NOTICE OF DECISION

URBAN GROWTH PRELIMINARY DECLARATION / CLASS 3 SITE PLAN REVIEW, CLASS 2 ADJUSTMENT / CLASS 2 DRIVEWAY APPROACH PERMIT / CLASS 1 DESIGN REVIEW CASE NO.: UGA-SPR-ADJ-DAP-DR23-01

APPLICATION NO.: 22-123981-PLN

SUMMARY: A consolidated application to develop a 90-unit multiple family development.

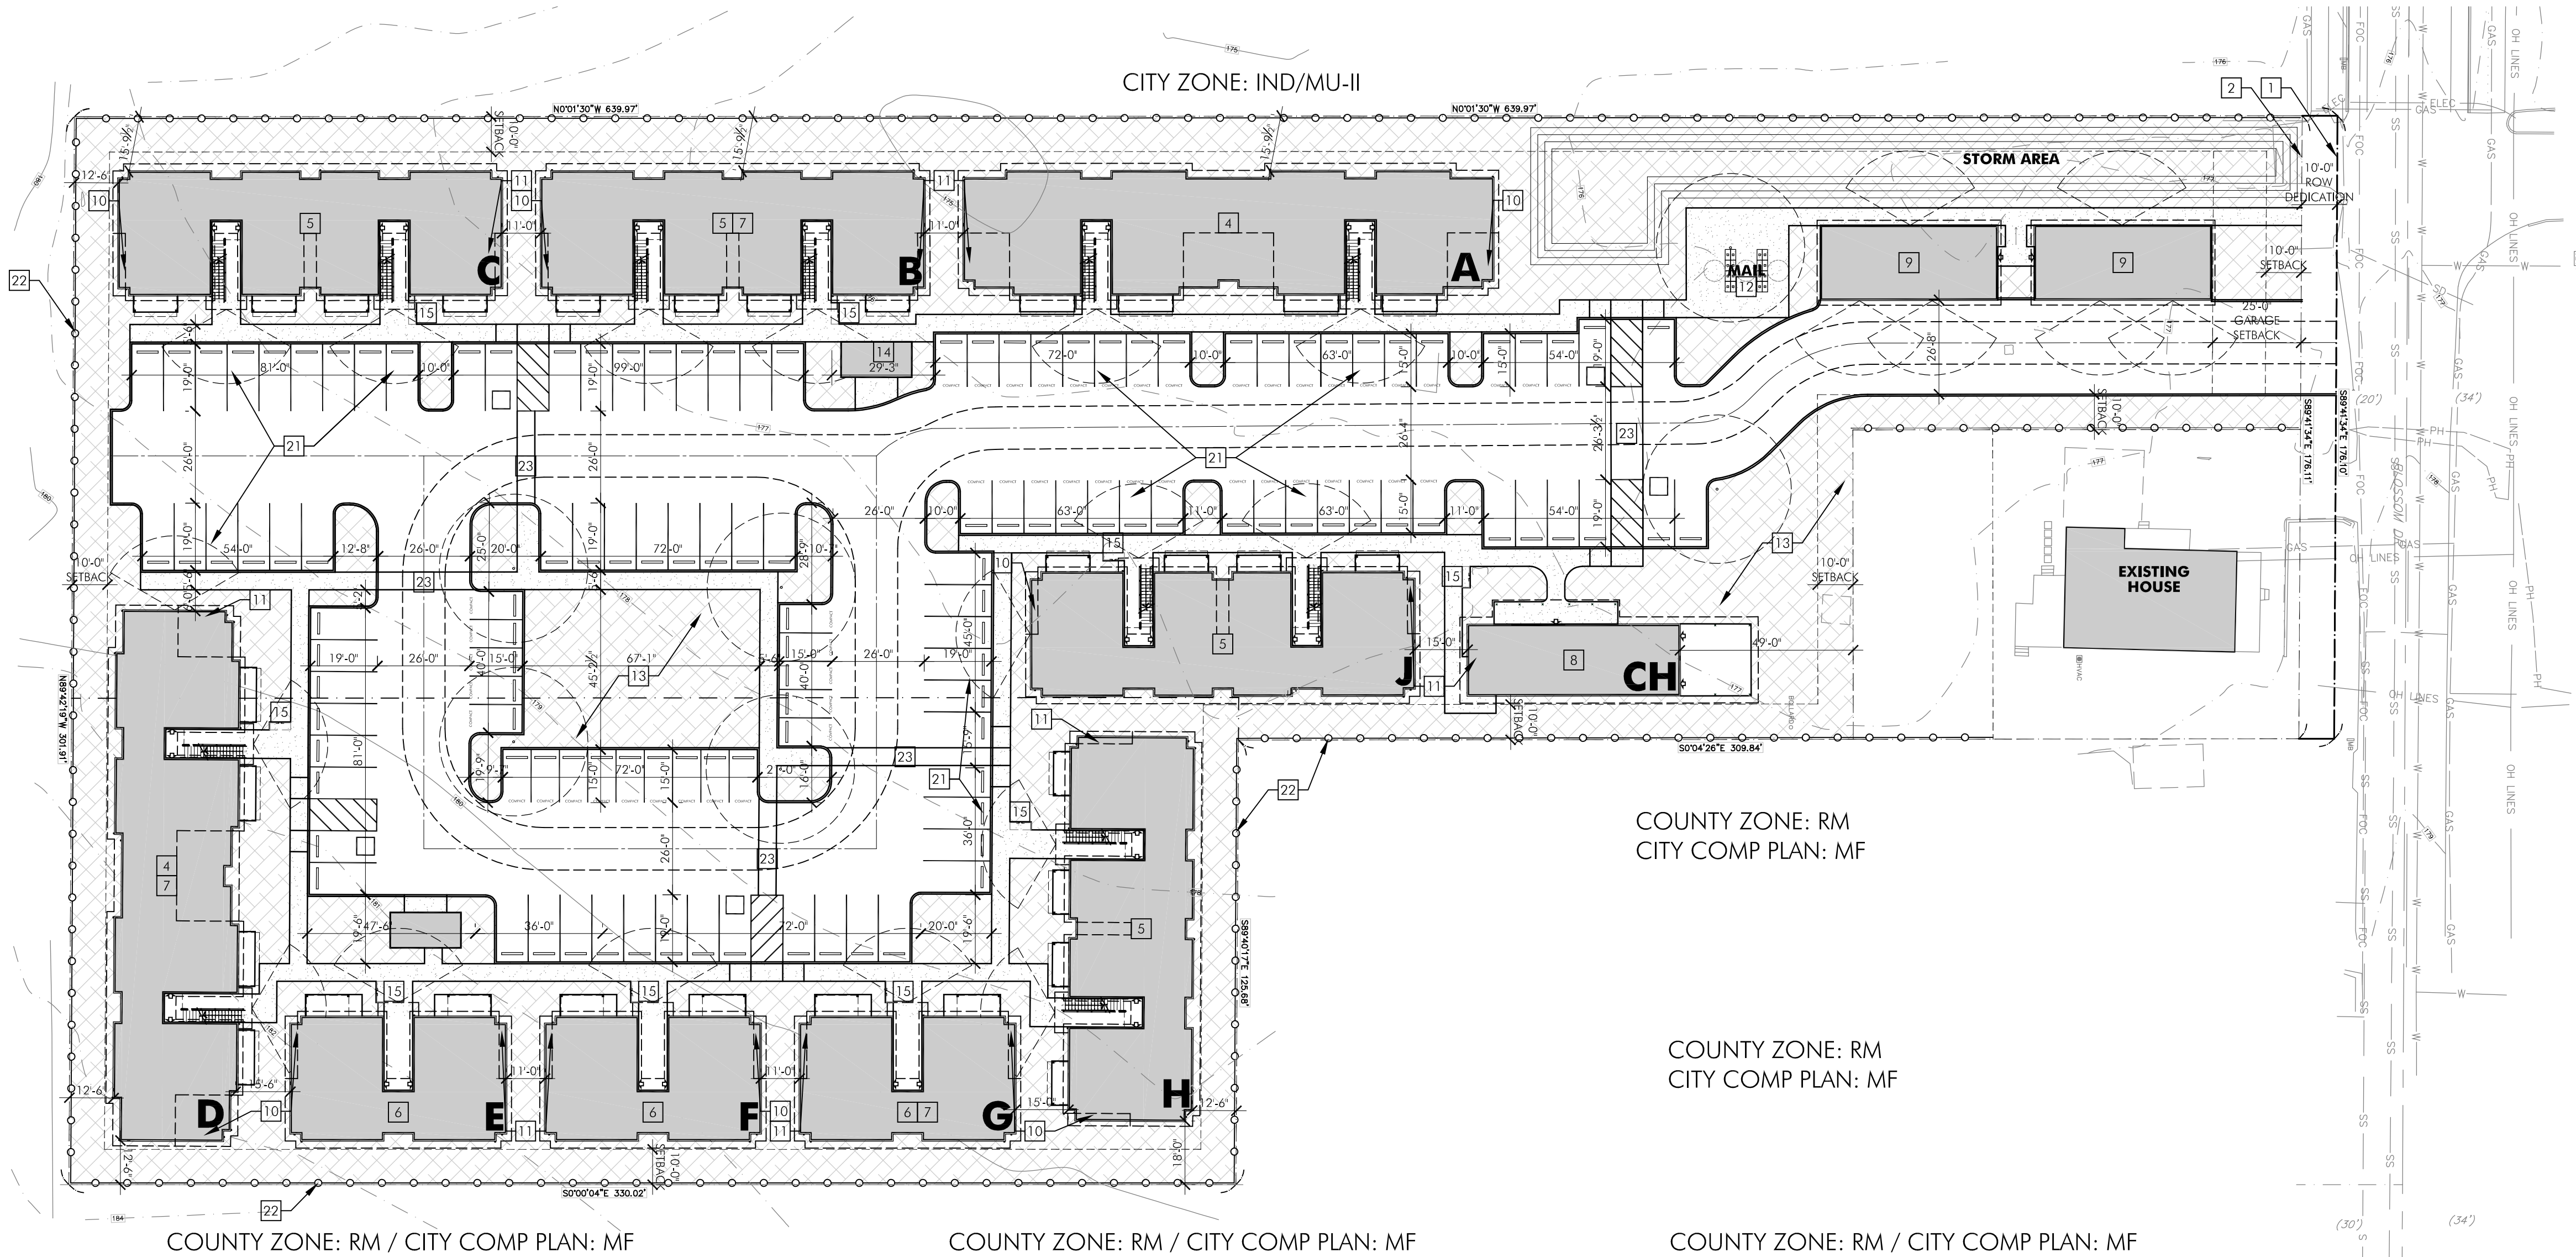
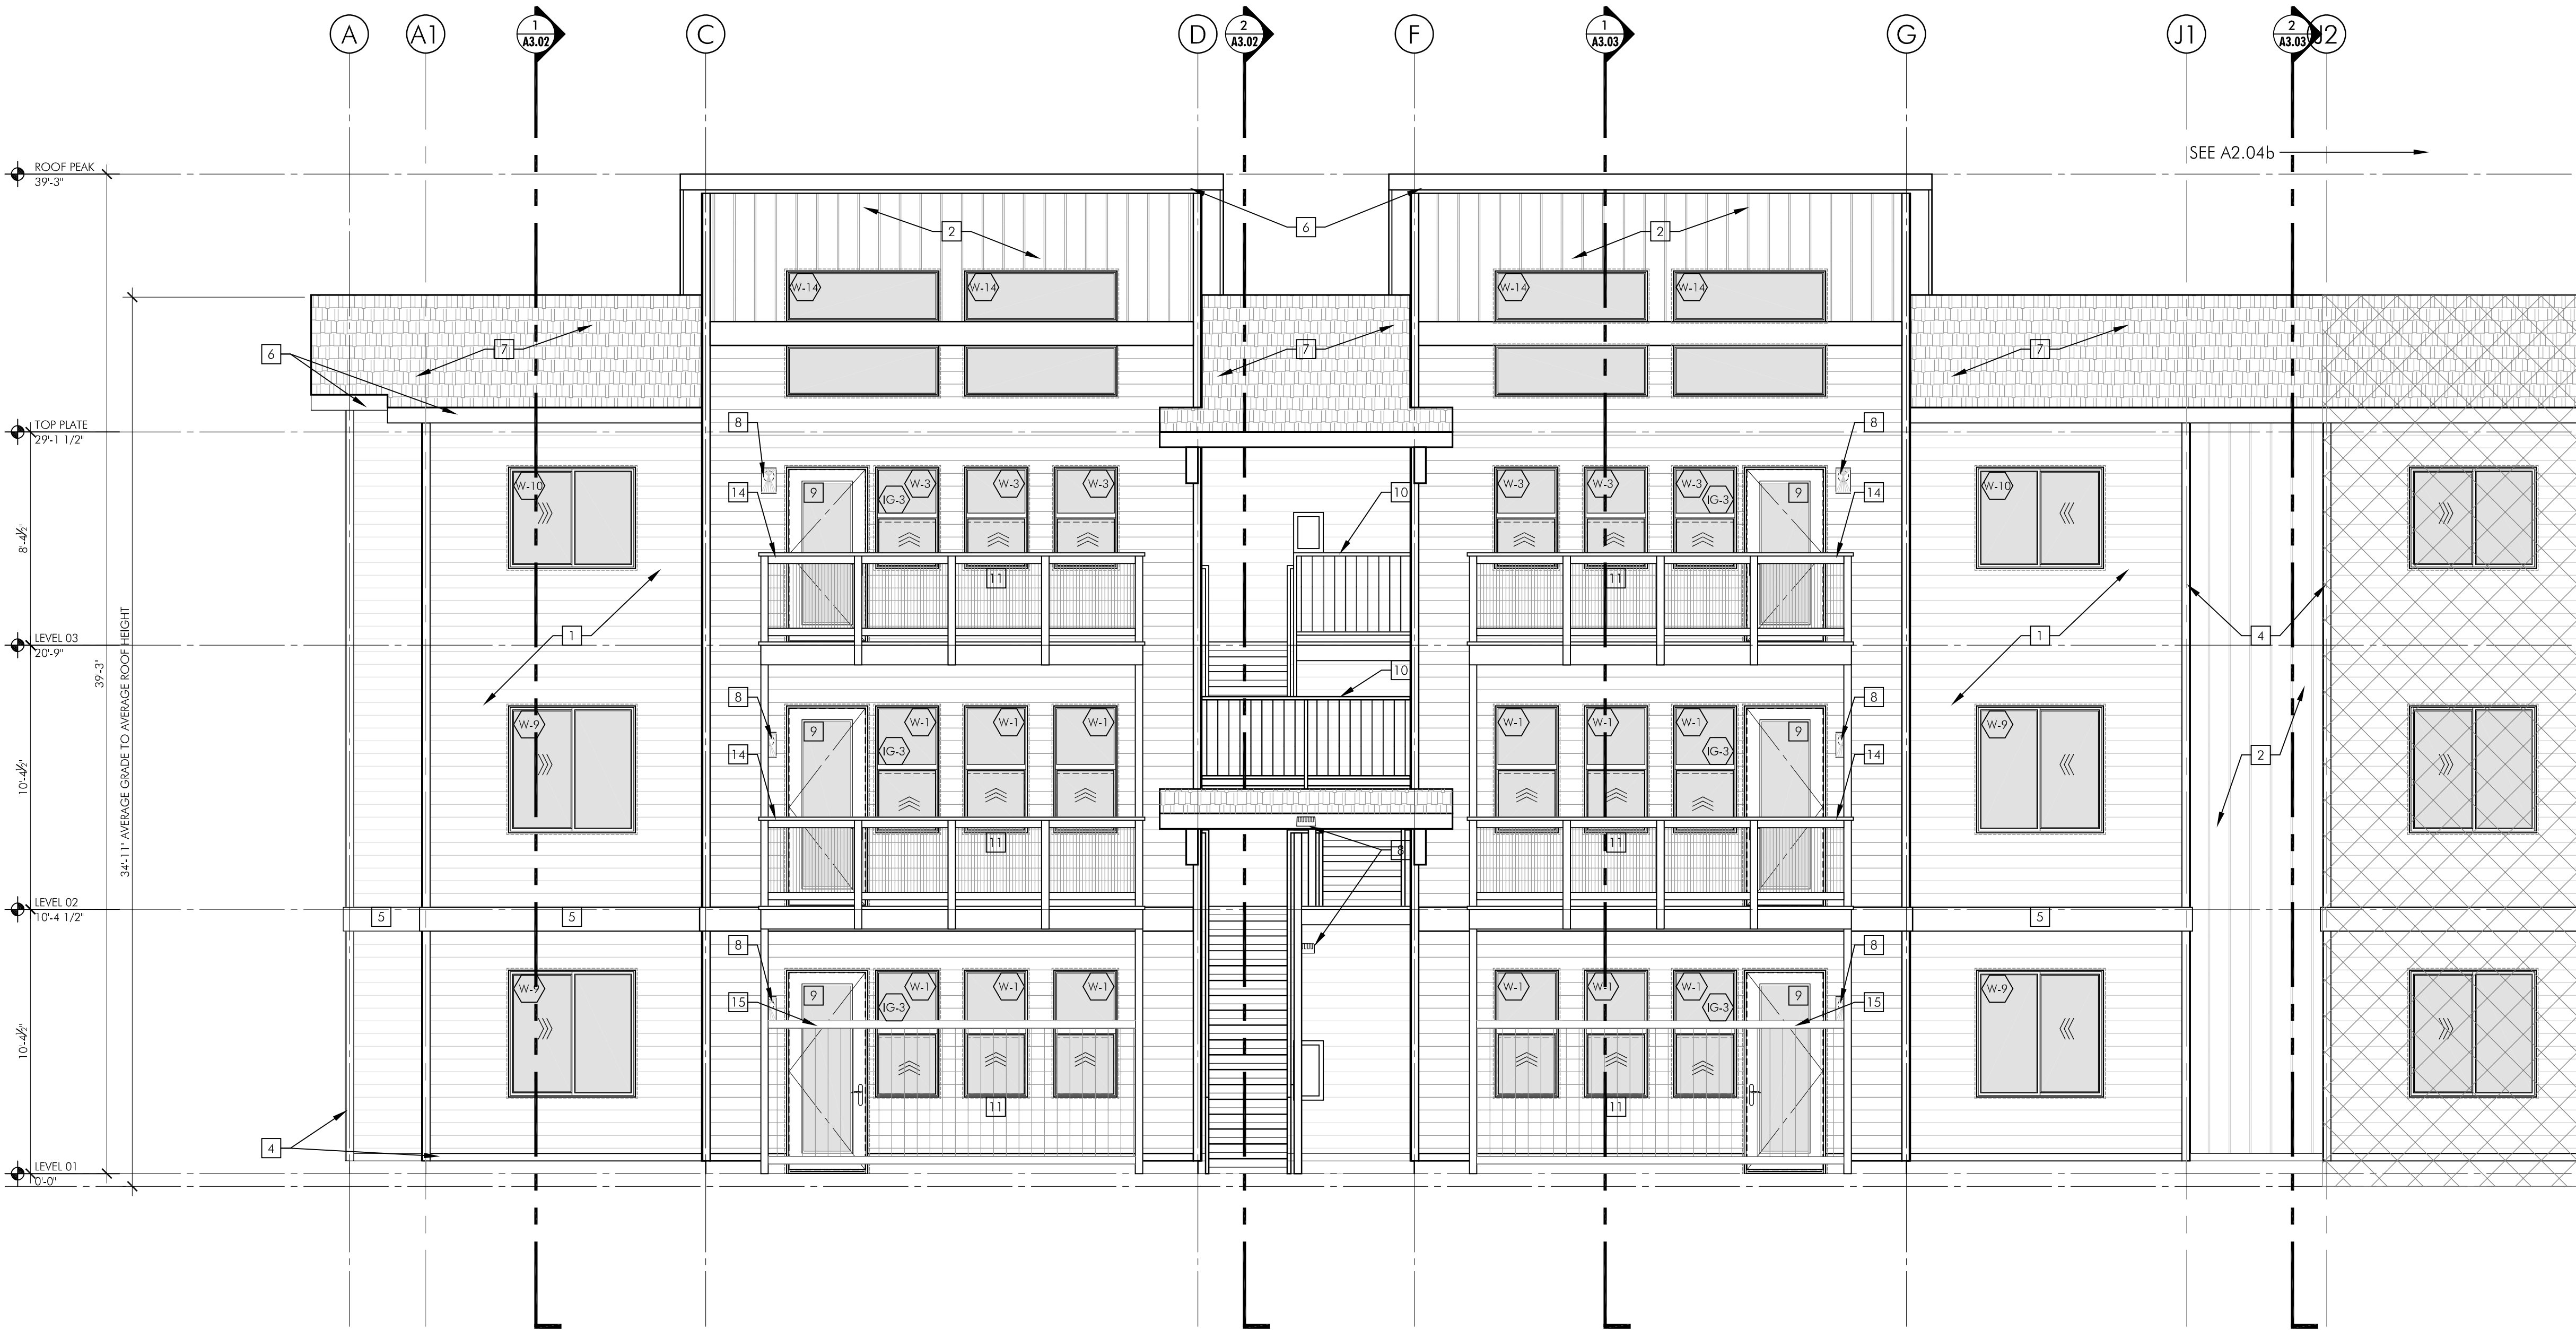
Finding: The total number of units for the proposed multiple family development is 90 dwelling units. The minimum number of off-street parking required is 90 spaces. The site plan indicates a 130 off-street parking stalls are provided, exceeding the minimum off-street parking.

The site plan indicates 47 of the proposed parking spaces are designated as compact. The compact parking space allotment standard set forth in SRC 806.015(b) require the maximum off-street parking stalls proposed for the site not exceed 119 ($90 \times 0.75 = 118.5$).

Finding: The site plan indicates bicycle parking to be with 50 feet of a primary entrance; therefore, this standard is met.

Finding: The site plan does not indicate fencing, walls or plant materials abutting the street.

Finding: The site plan indicates that pedestrian pathways are provided in a manner that connects each proposed structure and common open space. Measurements of the proposed pedestrian walkway throughout the development area are at least five feet in width; therefore, this standard is met.

Finding: The site plan indicates that none of the buildings exceed 150 feet. The longest building is 145 feet in length; therefore, meeting this standard.

Condition 1: At the time of building permit review, the applicant shall provide site plan details indicating conformance with SRC800.055(f)(4).
